**RE: Sanderway  
Carrboro, North Carolina  
SPEC-18092**

*McAdams was tasked with reviewing the stormwater design calculations and construction drawings provided to us by Jeff Kleaveland from the Town of Carrboro on August 30<sup>th</sup>, 2018. The purpose of this review was to determine how/if the Sanderway development meets the Town of Carrboro stormwater rules and to determine what analyses were performed to ensure the downstream neighbors will not be adversely impacted by the proposed Sanderway development. The following questions/comments were generated from the review and require additional information to ensure all applicable requirements are being met for the proposed development:*

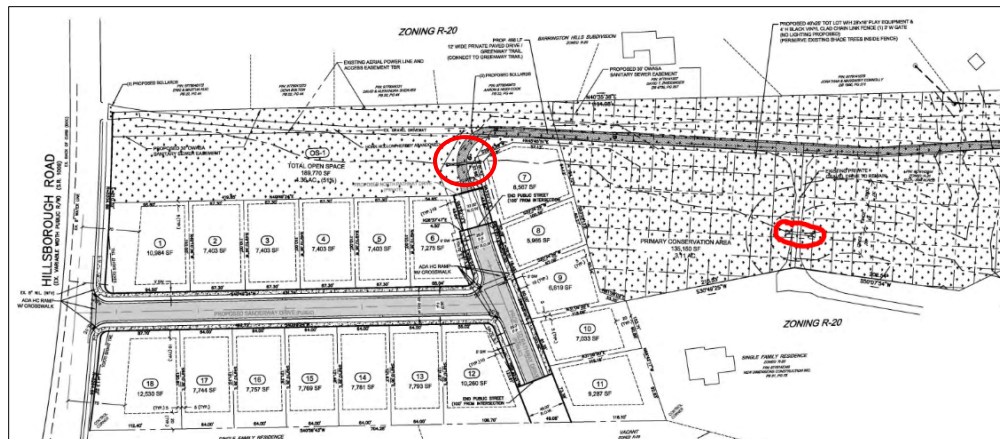
- Is there a detention exemption for the site that gets the proposed development out of 1-, 2-, 5-, 10-, and 25-year storm peak flow detention? No hydrograph analysis has been presented for review to back up the detention requirements of the ordinance.
- No information was provided to support a peak flow analysis was completed at the locations circled below and where runoff leaves the Sanderway property.

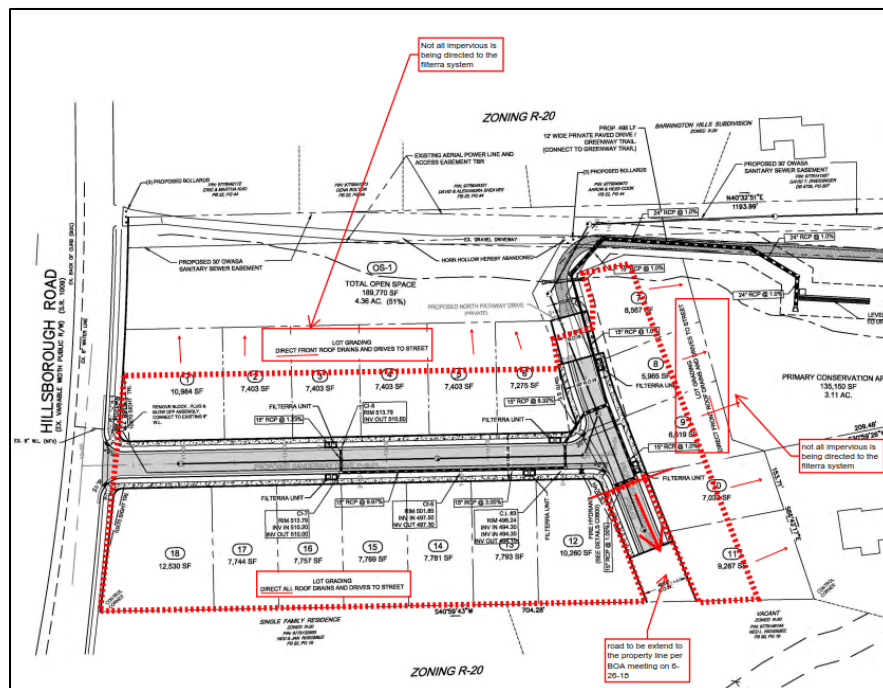
- No calculations are provided to support 85% average annual removal rate for Total Suspended Solids (TSS)
- No bypass impervious is shown in the SNAP tool, although the utility plan (sheet C0300) mentions that some areas will only take the front roof drains to the system (impervious areas on site are bypassed and do not enter the stormwater treatment system).

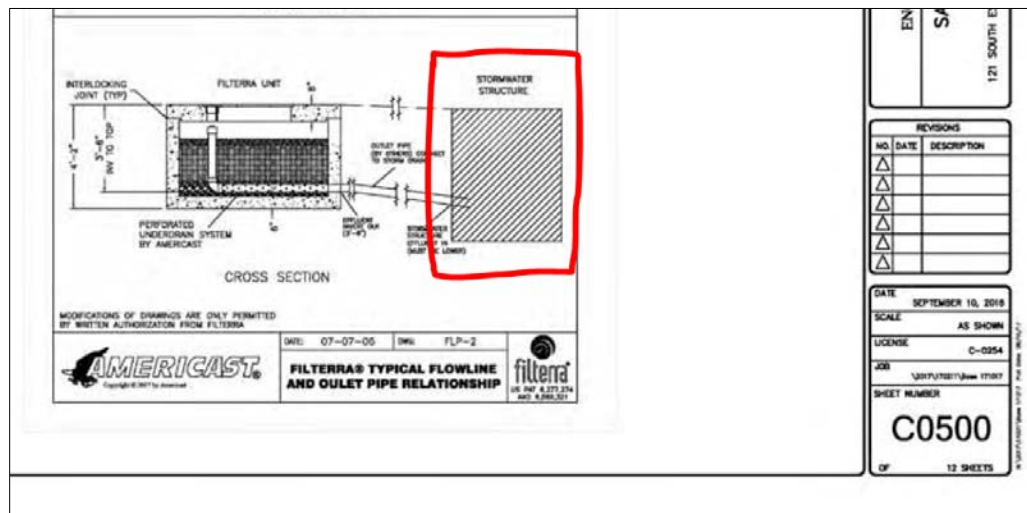
- No calculations were provided to show the “preexisting Composite Curve Number” that was used to determine the “Maximum allowable increase in annual stormwater runoff volume.”

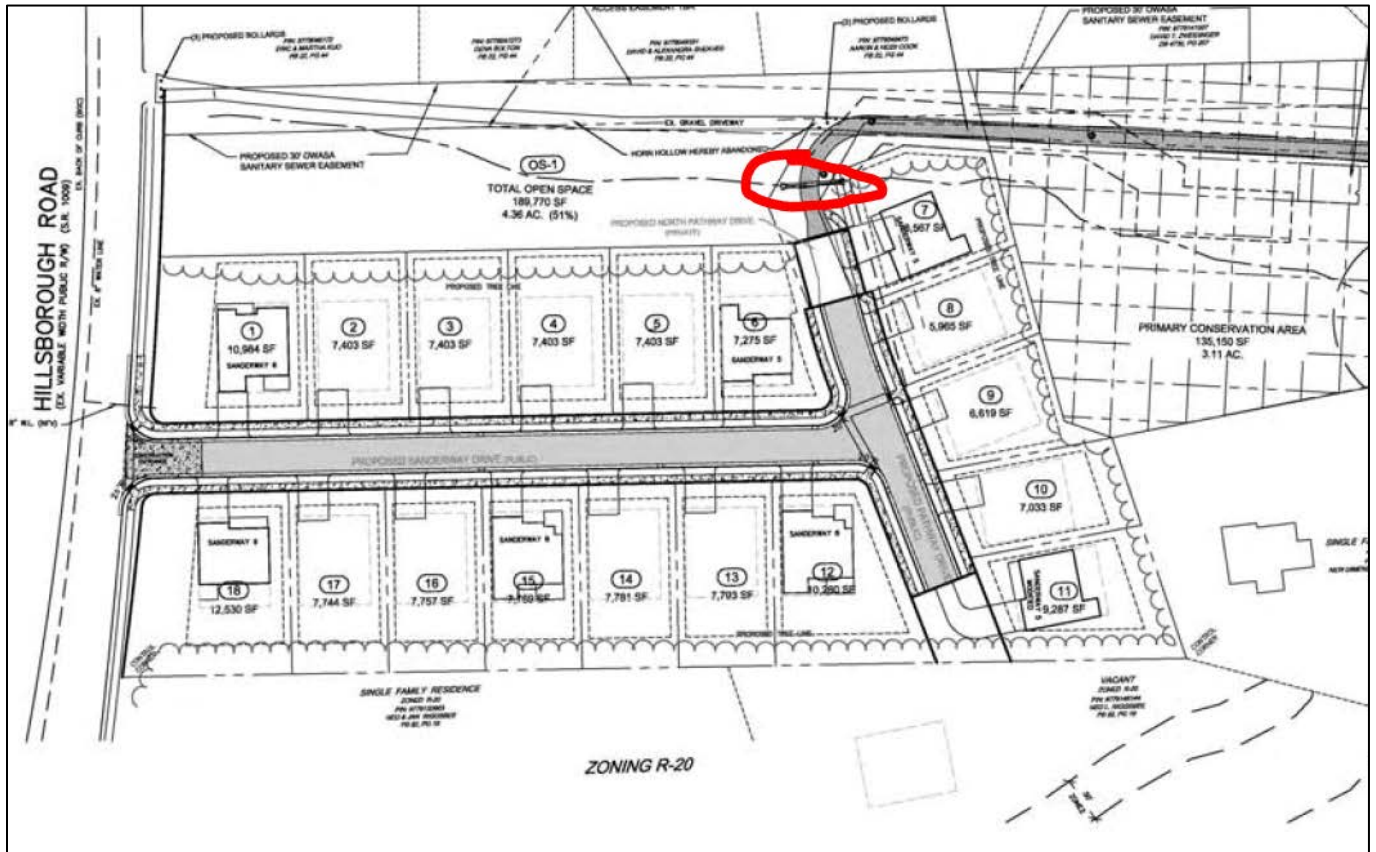
- Is the existing 12" culvert where Sanderway connects to the greenway being replaced? Not labeled on plans

- No outlet structure detail is provided for the “Stormwater Structure” that is supposed to be providing detention
- No level spreader details are provided
- No splitter box details are provided.
- No riprap is specified on the plans at the outfall.
